Robert Pyke, Consulting Engineer

May 26, 2014

Comments on the BDCP Public Draft EIR/EIS

Figure 1 – Monthly Delta Exports for Low Outflow Scenario

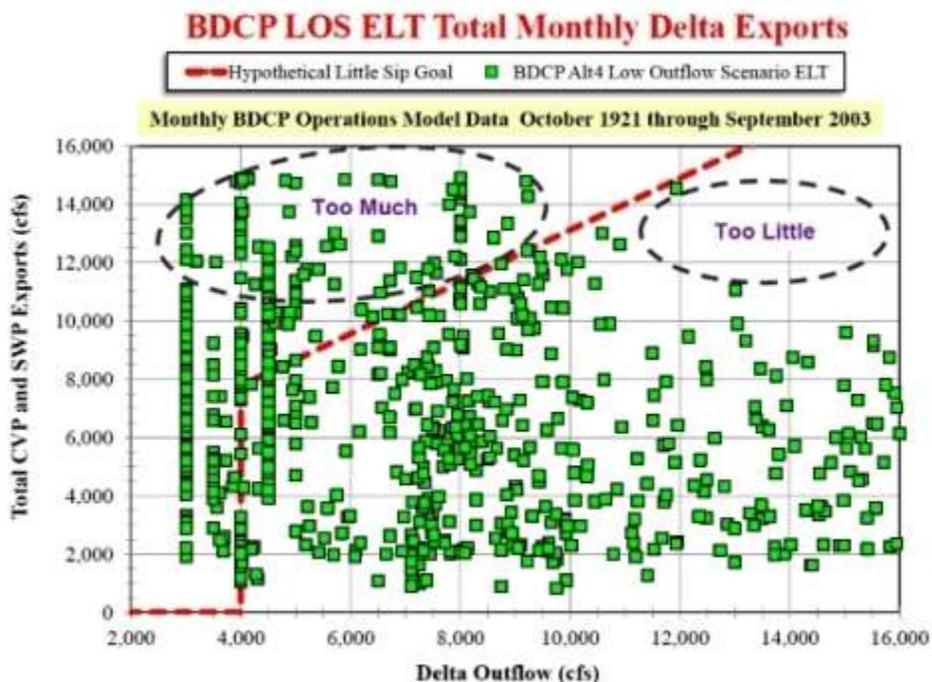
In summary, the principal objectives, purpose and need that are detailed for purposes of compliance with CEQA and NEPA are not met by the preferred alternative, or any other alternative that is described in the Plan or the EIR. There is no convincing evidence of any overall improvement in the Delta ecosystem - there may be marginal improvement in expectations for Delta smelt but expectations for salmon are made more problematic

– and there is no expectation that the SWP and the CVP will deliver up to full contract amounts under any hydrological condition – the interpretation of the results buried in the EIR/EIS by the BDCP staff is that exports will be maintained at present levels, plus or minus 10 percent, except that exports may have to be reduced if species recovery goals are not met, a circumstance that appears to have a high probability of occurrence. In fact, even the projection of maintaining exports at something like present levels is a fiction. Figures 1 and 2, kindly provided by Richard Denton, show that in order to achieve this overall level of exports, it is necessary to resort to more pumping in drier months than is the case at present. It is not easy to trace the effects of this through the present effects analysis, but this might be one of the reasons that the effects analysis does not show sufficiently positive results to justify the granting of incidental take permits. If the operational rules were to be changed so that the effects analysis suggests more positive results for salmonids, the volume of exports would immediately be reduced. These figures also show that it is ludicrous for BDCP proponents to talk about taking a “little sip, big gulp approach”, that is to take more water at periods of high flows and little or no water at periods of low flows. The BDCP does not in fact include the necessary physical components to do that. It should also be noted that it is unclear whether the aqueducts can presently carry the combined maximum exports of 14,400 cfs shown in Figures 1 and 2 because of subsidence caused by excessive pumping of groundwater, so that it is doubly questionable whether the planned level of exports can actually be achieved.

Figure 3 – Delta Inflow and Outflow

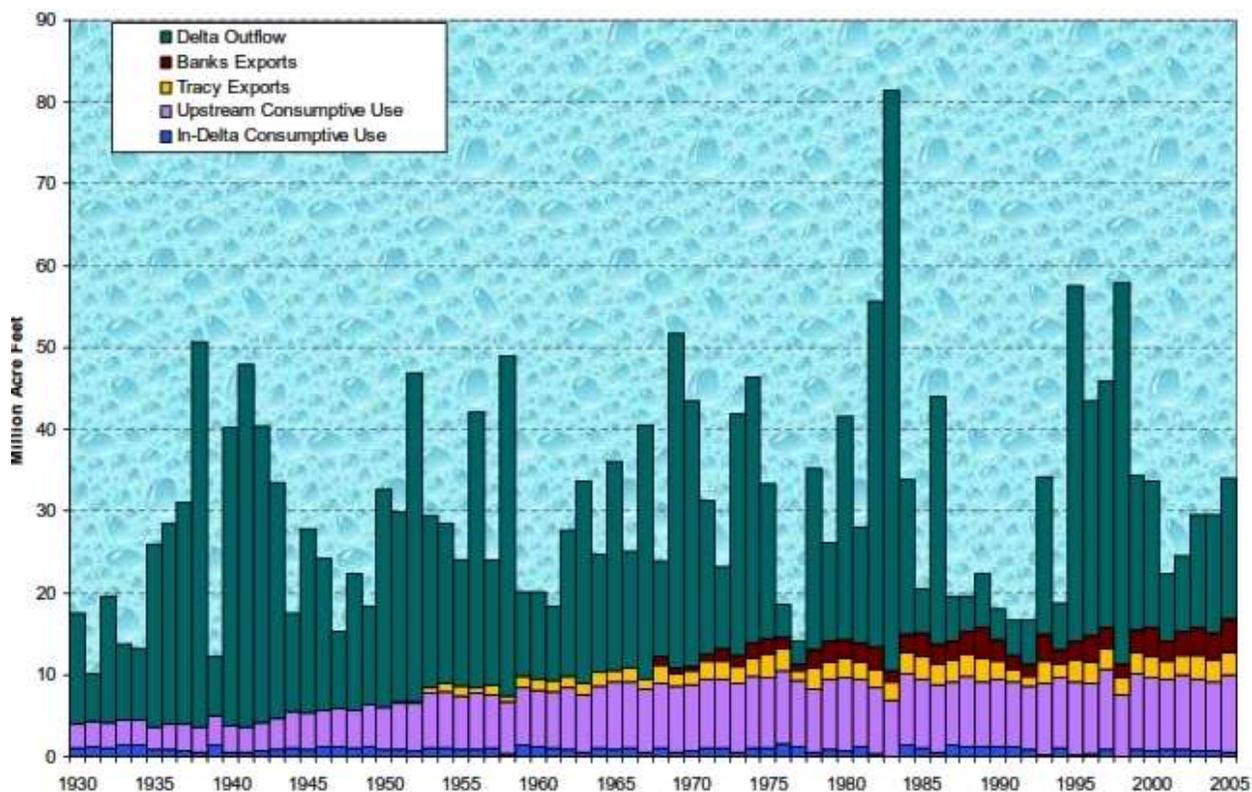
Consideration of the water supply reliability question has to start with recognition that not only does two-thirds of the precipitation in California fall in the northern half of the

State while two-thirds of the population live in the southern half of the State, but also with recognition that in California precipitation is not evenly distributed over time but tends to come in bunches of wetter than normal years and then bunches of drier than normal years (droughts), as may be seen in Figure 3. This is just as important as the geographical distribution of precipitation. It may be noted in Figure 3 that earlier last century a decent amount of water passed out of the Delta to the Bay and the Ocean even in dry years (the green bars). But now in periods of drought very little water passes through the Bay to the Ocean. While there are other stressors on the Bay Delta ecosystem, it is inescapable that the lack of Delta outflow in dry years coupled with the cross flow within the Delta that leads to millions of fish being captured and subsequently dying in the fish salvage facilities associated with the South Delta pumps, has had a major adverse impact on both the Bay Delta ecosystem and the viability of salmon runs that have existed for 7,000 years or so through mediaeval warm periods and the Little Ice Age but are now threatened with extinction.

Figure A1 – Cross Section through Permeable Embankment

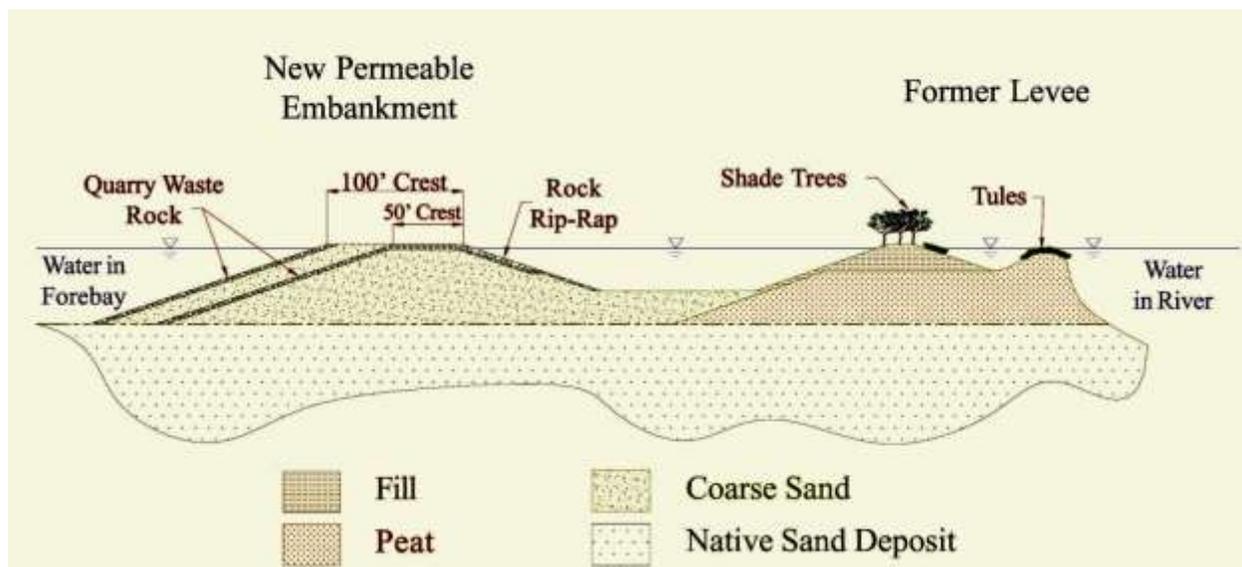
31 The Pyke Proposal calls for permeable levees²¹ to allow water to enter Sherman Island while
 32 avoiding or reducing fish entrainment. Although, in concept, the reduction in entrainment is an
 33 excellent feature, the construction of the proposed levees would likely be impractical. Levee designs
 34 that include rock and sand to reduce fish entrainment in the facilities are of limited use and success
 35 in a project this size. A permeable embankment capable of passing 15,000 cfs at a velocity of 0.002
 36 ft/sec (100 times less than existing approach velocity criteria) would have to be about 95 miles long
 37 (assuming 15 feet of wetted area). Sherman Island only has about 19.5 miles of existing levees.

The assertion that “construction of the proposed levees would likely be impractical” is unsupported and is incorrect. The proposed permeable embankments have been conceived by geotechnical engineers that have extensive design and construction experience. The proposed cross-section is shown in Figure A1.

The new permeable embankment would be constructed using hydraulic dredging techniques subsequent to the removal of the peat but before the existing levees are breached. Excavation of the peat adjacent to the existing levee would take place only at times of low water and would be done in short segments with the sand fill that abuts the existing levee being placed immediately in order to control underseepage. Careful site investigations using advanced geophysical techniques would be used to identify possible locations requiring special treatment. The hydraulic dredging techniques that would be used both to remove the peat and place it in the areas designated for new habitat and for borrowing and placing sand and gravel for the permeable embankments are in use world-wide on major port, airport and land reclamation projects and represent the cheapest possible way of moving earth material. The cost per cubic yard of moving and placing earth materials using these techniques can be an order of magnitude cheaper than using trucks or barges.

Figure A2 – SLOPE/W Analysis

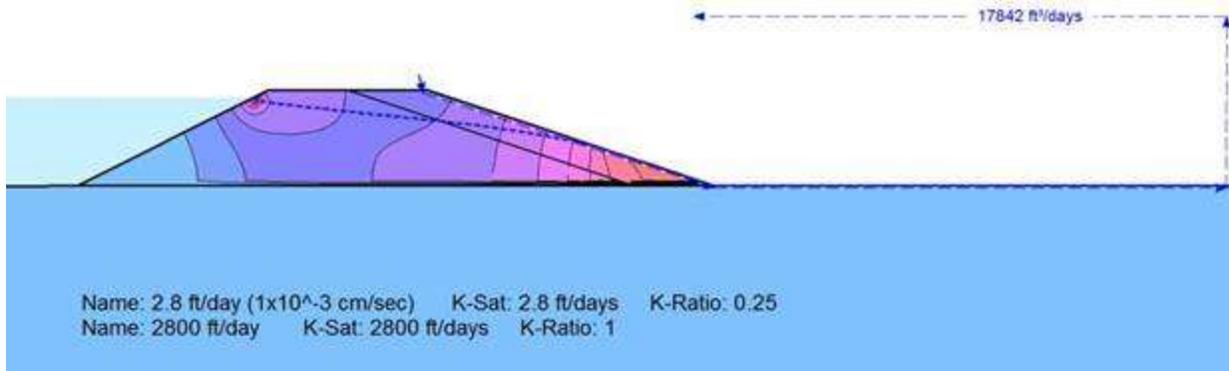
15,000 cfs with maximum approach velocities in the order of 0.002 ft/sec could in fact be obtained using the proposed geometry. The vertical height of the wetted surface would in fact be approximately 50 feet, not 15 feet as illustrated in the following cross section:

Figure A3 – Variation of Approach Velocity with Elevation

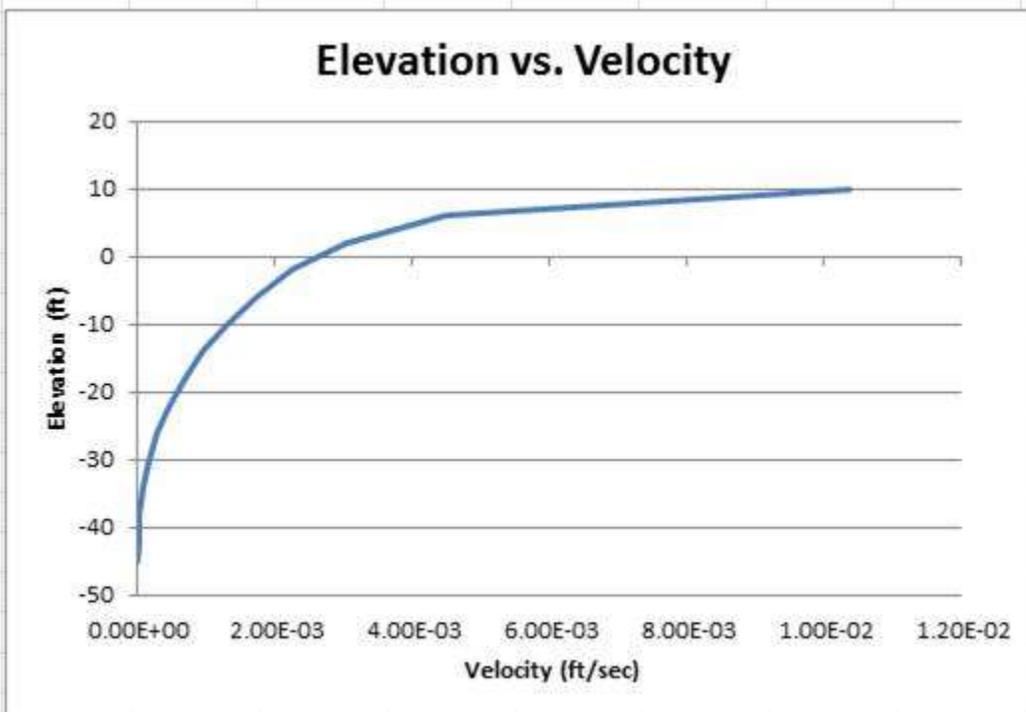
It should also be noted that because of the embankment geometry, the approach velocities are generally much less than the maximum value:

Figure A4 – The Western Delta Intakes Concept

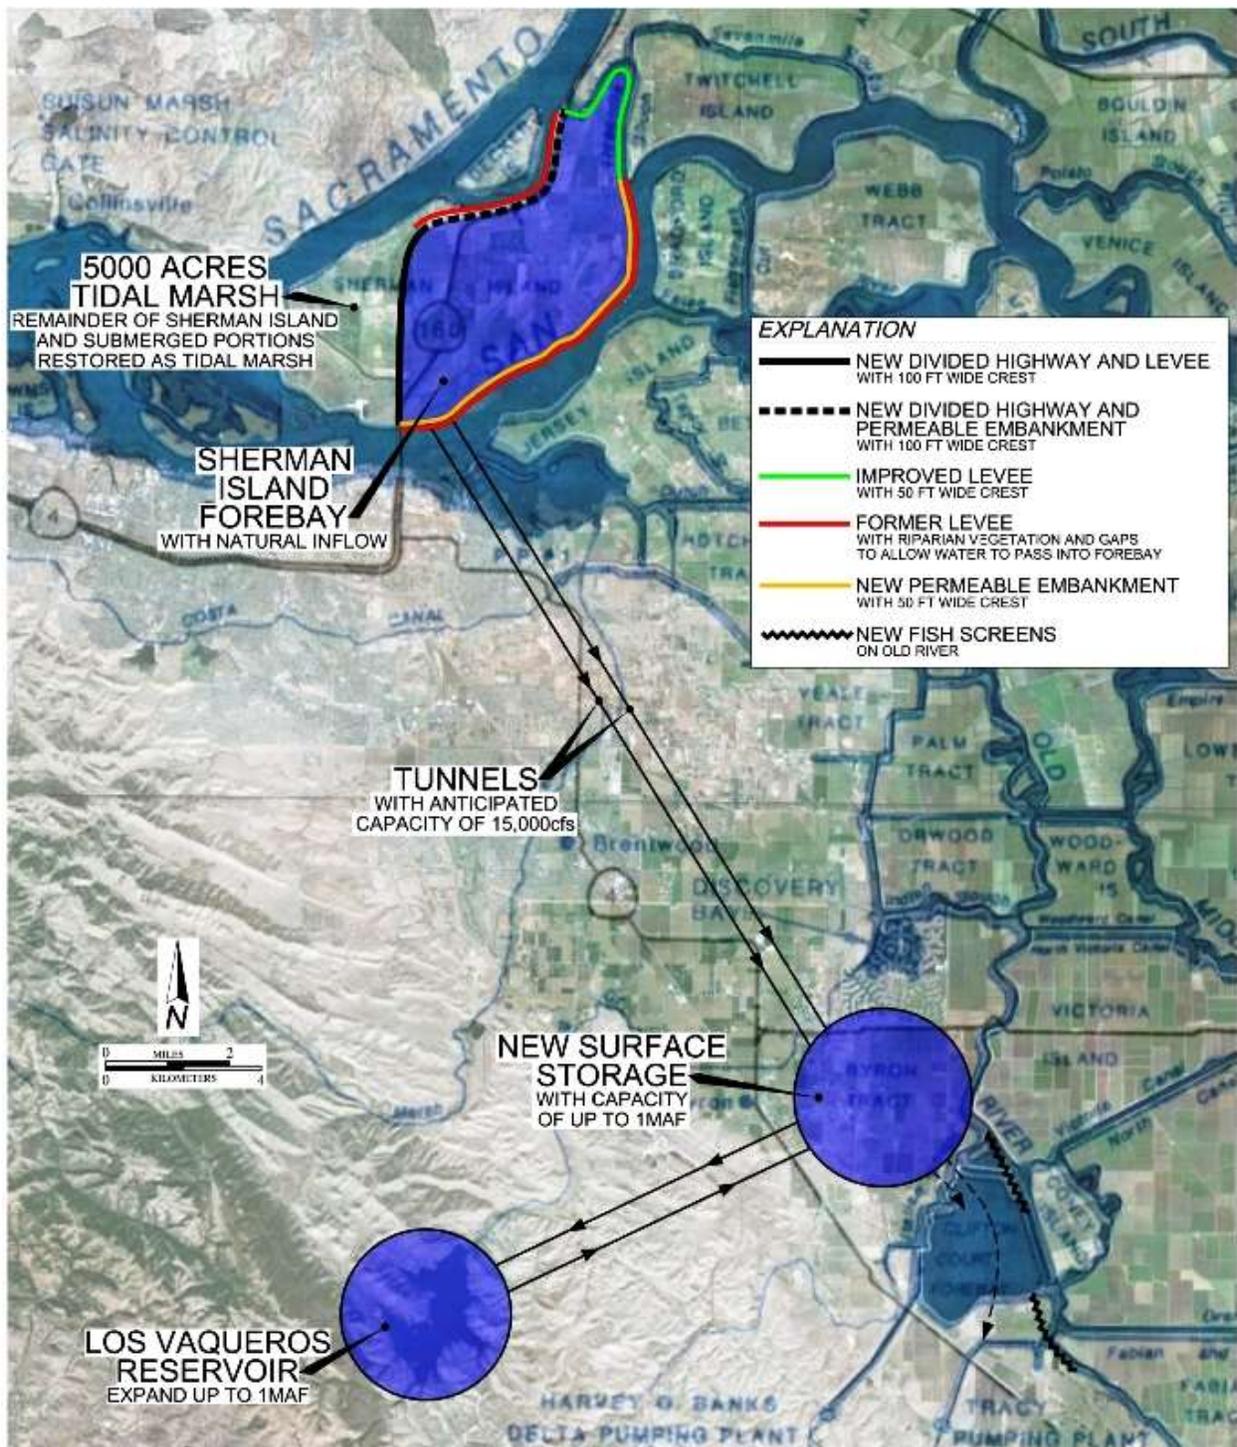
6 Inundation of Sherman Island would create its own problems. Constructing a reservoir in the
 7 western Delta on peaty soils combined with more saline water will increase the potential
 8 formation of trihalomethanes. Alternatively, should the peat soils be removed during construction,
 9 very substantial amounts of excavation, with attendant environmental impacts, would be necessary.
 10 Although the actual size of the Sherman Island Forebay has not been described, it would need to be
 11 at least several hundred acres to provide an operational buffer and take advantage of off-peak
 12 pumping. At some locations on Sherman Island, the peat can be up to 40 feet deep. Assuming the
 13 forebay size to be 750 acres and the average depth of peat to be 20 feet, removal of over 653 million
 14 cubic yards could be required.

The size of the proposed Sherman Island Forebay is shown in Figure A4 and the figures included in the white paper that describes the WDIC (see <http://fixCAwater.com>). Note that the potential use of Los Vaqueros Dam is only conceptual and would require negotiation with the Contra Costa Water District. Los Vaqueros is presently restricted to local use only.

The white paper makes it clear that the peat would be removed using hydraulic dredging techniques and used to create tidal and sub-tidal habitat on the western portion of Sherman Island and the submerged portion of Sherman Island that lies further west. While the volumes involved are substantial, the cost of moving this material would be relatively small and it constitutes a win-win, for both water supply and the environment.

Figure B1 – Levee Failure Rate

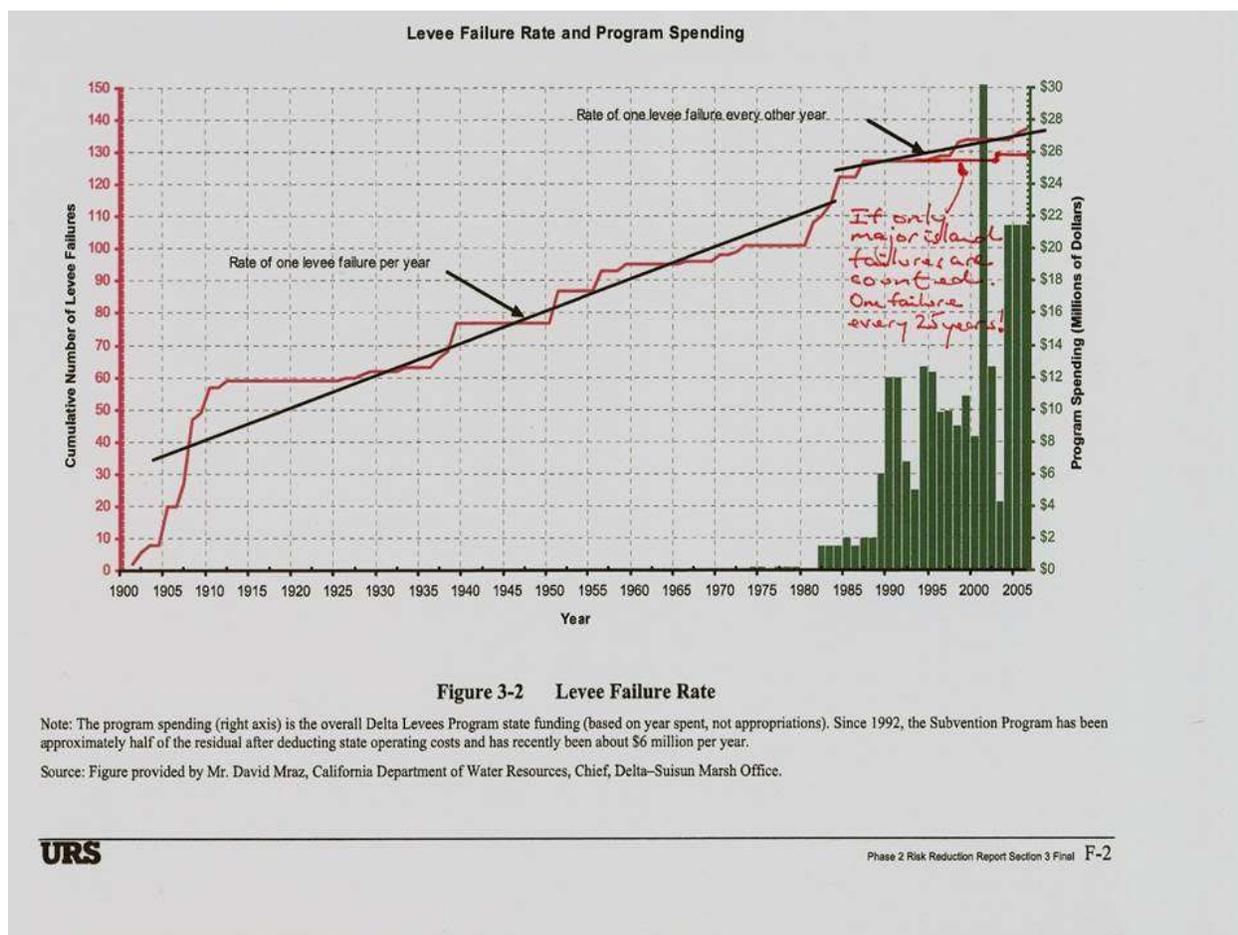
According to the Delta Risk Management Strategy (DRMS), Phase 1: Risk Analysis (California Department of Water Resources 2007), the risk of levee failure in the Delta is significant. Since 1900, 158 levee failures have occurred (California Department of Water Resources 2008b). Some islands have been flooded and recovered multiple times. A few islands, such as Franks Tract, have never been recovered.

See above for the limitations of the DRMS Phase 1 study. The actual rate of failure is shown in Figure B1, prepared by DWR and taken from the DRMS Phase 2 report. DWR staff are justifiably proud of the improvement that has resulted in the Delta levee system as a result of programs that they have managed, however, the DWR data includes a number of levees failures in 1997 that were upstream of the Delta proper or were of levees that are not currently being maintained, and if these are deleted, the current rate of levee failures is even lower, as shown in the correction in red ink in Figure B1 that has been made by the writer.
